Access Compliance Report

Public Rights-of-Way

(Curb Ramps)

Intersection ID: 12073	Main Street: E_11TH_ST	Cross Street: N_CALDWELL_ST	Location: S
ADA ID: C24323C31C09	Ramp Type: PerpDiag	Initial Pass/Fail: Fail	Overall Compliance: No
		Severity Score: 10

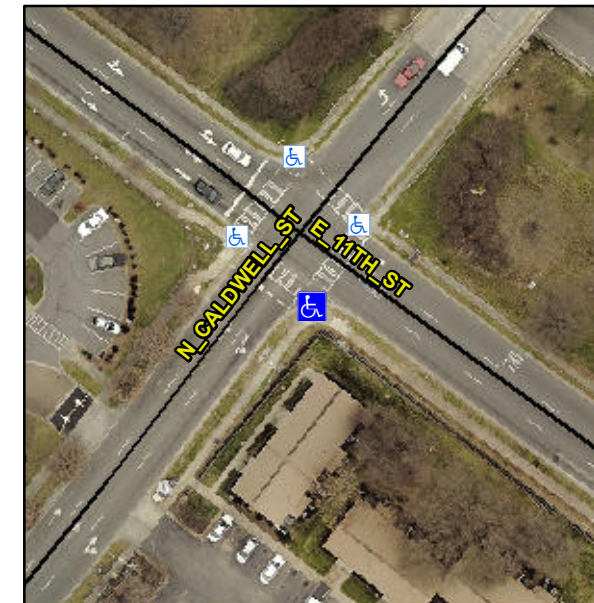
Not Found, R304.5.1, R304.5.3

Compliance	Description	Data	Compliance	Description	Data
N/A	Ramp Length (in)	100.0	Yes	Ramp Slope (%)	6.4
No	Ramp Width (in)	40.0	No	Ramp XSlope (%)	2.9
N/A	Flare Type LT	N/A	N/A	Flare Type RT	N/A
N/A	Flare Slope LT (%)	N/A	N/A	Flare Slope RT (%)	N/A
N/A	Flare Traversable LT?	N/A	N/A	Flare Traversable RT?	N/A
N/A	Landing Length (in)	N/A	N/A	DWS Provided?	N/A
N/A	Landing Width (in)	N/A	N/A	DWS Contrast?	N/A
N/A	Landing Slope (%)	N/A	N/A	DWS Length (in)	N/A
N/A	Landing X Slope (%)	N/A	N/A	DWS Full Width?	N/A
N/A	Landing Curb? (Y/N)	N/A	N/A	DWS Offset (in)	N/A
N/A	Shared Landing?	N/A			
N/A	Gutter Ponding?	N/A	N/A	Gutter Slope (%)	N/A
N/A	Gutter Lip Ht (in)	N/A	N/A	Gutter X Slope (%)	N/A
N/A	Painted X Walk1?	Yes	N/A	Painted X Walk2?	Yes
	X Walk 1 Direction	To NE		X Walk 2 Direction	To NW
N/A	X Walk 1 Width (in)	112.0	N/A	X Walk 2 Width (in)	101.0
	X Walk 1 Slope (%)	4.7		X Walk 2 Slope (%)	0.6
	X Walk 1 X Slope (%)	2.0		X Walk 2 X Slope (%)	3.9

Remove & Replace Curb Ramp With Two New Directional Ramps or Equivalent.
